Field Application Document (FA)

FIELD CHANGE ORDER	NUMBER: KA45-F002 KA47-F002
--------------------	--------------------------------

APPLICABILITY: This "F" coded FCO should be installed in all Microvax 3100 Model 30, 40, and 80 which contain part rev below M02 or M03 for FRU 54-20654-01 (Model 30 and Model 40) and part rev below J02 or J03 for FRU 54-20652-01 (Model 80). This FCO incorporates ECO No. 54-20654-TWO007 for Model 30 and Model 40 and ECO No.5420652-TWO006. Please do not make a separate trip just to install FCO unless customer is down. Install the FCO next time you go to the Customer site.

Figure 1 - Diagram of KA45-AA CPU Board used in MicroVAX 3100-30, -40

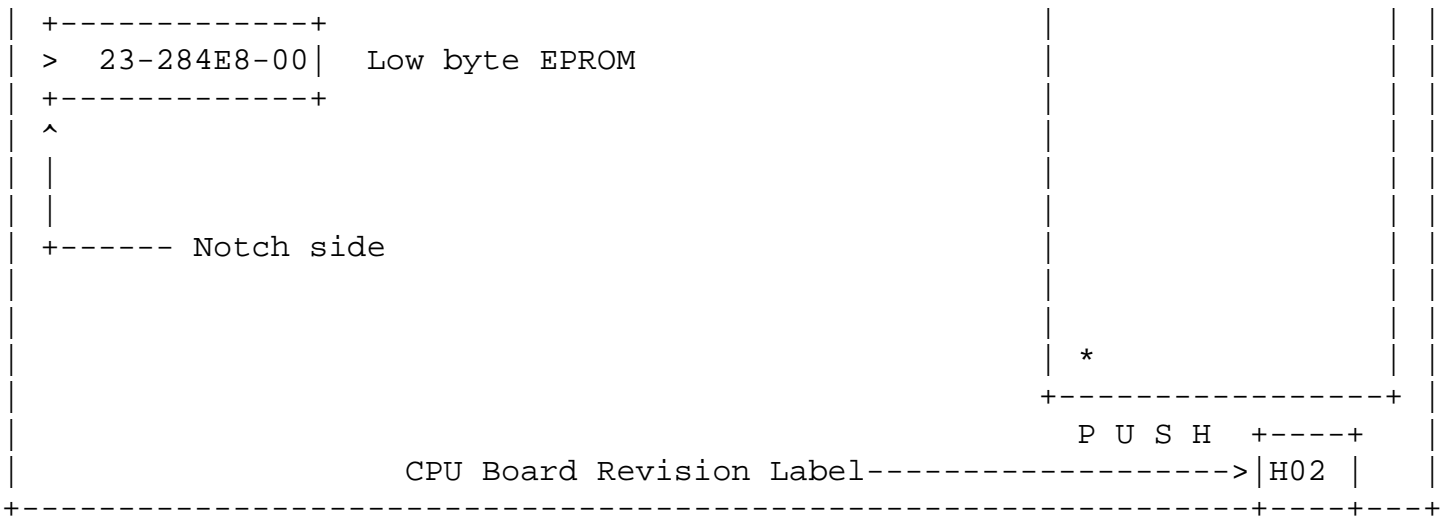
- a. Refer to Figure 1 if your system is a Model 30 or 40, or Figure 2 for a model 80 for the location of the firmware EPROM's that need to be replaced.

- b. Locate the firmware EPROM with either part number 23-150E8-00, 23-224E8-00, or 23-267E8-00 (High Byte). Use an IC remover or small screw driver to remove the EPROM from the socket. Replace with EPROM 23-285E8-00 supplied in the kit. Observe the orientation of the notch in the ROM package.

c. Locate the firmware EPROM with either part number 23-149E8-00, 23-223E8-00, or 23-266E8-00 (Low Byte). Use an IC remover or small screw driver to remove the EPROM from the socket. Replace with EPROM 23-284E8-00 supplied in the kit. Observe the orientation of the notch in the ROM package.

Replace ROM 23-266E8-00 or ROM 23-223E8-00 or ROM 23-149E8-00 at location E167 with new ROM 23-284E8-00 and replace ROM 23-267E8-00 or ROM 23-224E8-00 or ROM 23-150E8-00 at location E168 with new ROM 23-285E8-00.

Figure 2 - Diagram of KA47-AA CPU Board used in MicroVAX 3100-80

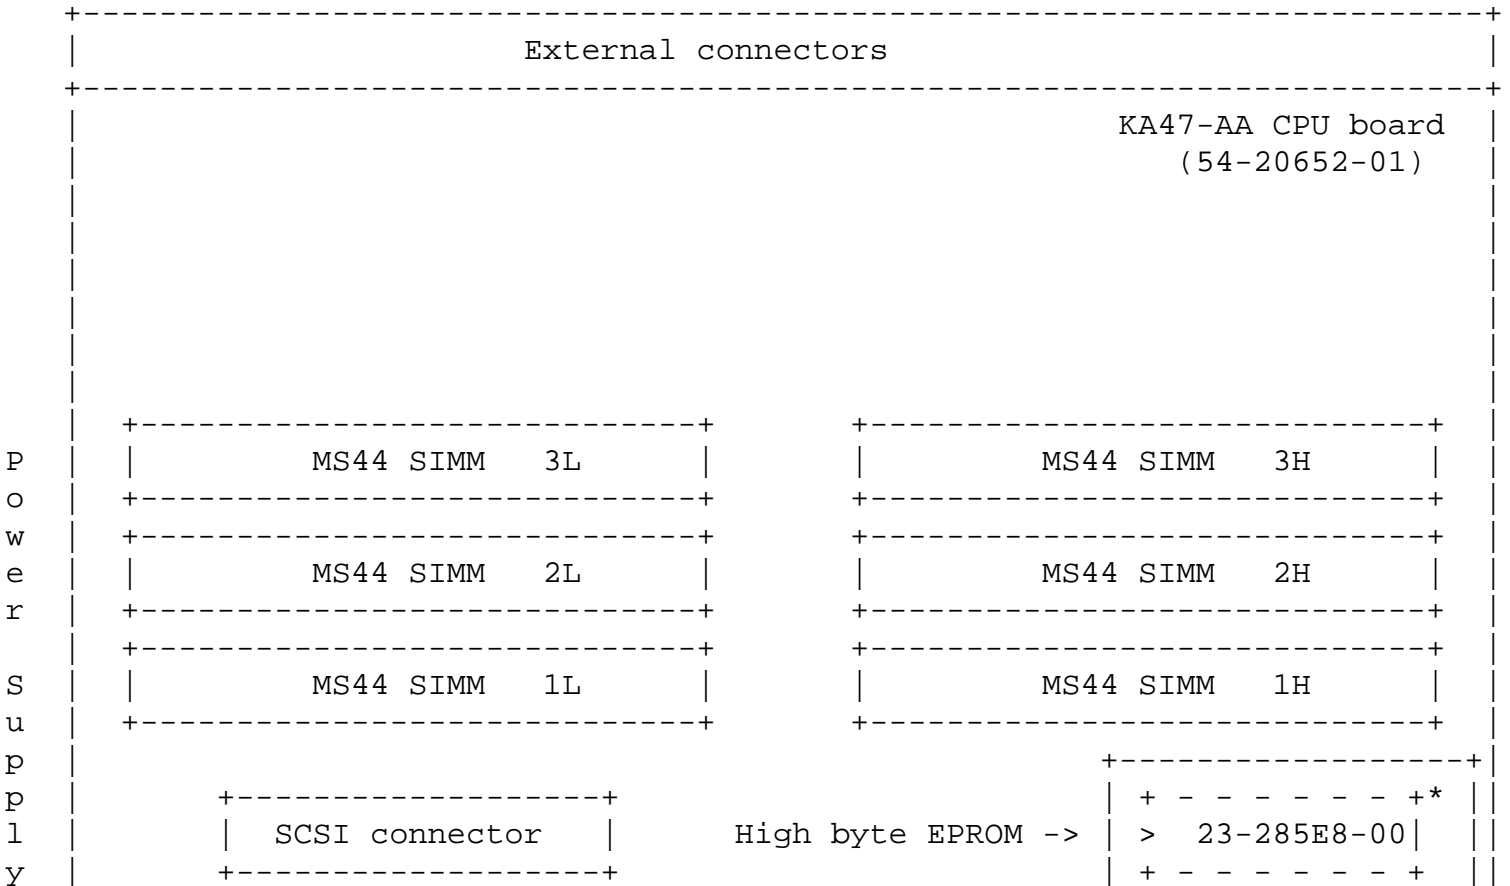
Both EPROM's are
located under the
54-20662-01 logic board

Replace ROM 23-266E8-00 or ROM 23-223E8-00 or ROM 23-149E8-00 at location E15 with new ROM 23-284E8-00 and replace ROM 23-267E8-00 or ROM 23-224E8-00 or ROM 23-150E8-00 at location E16 with new ROM 23-285E8-00.
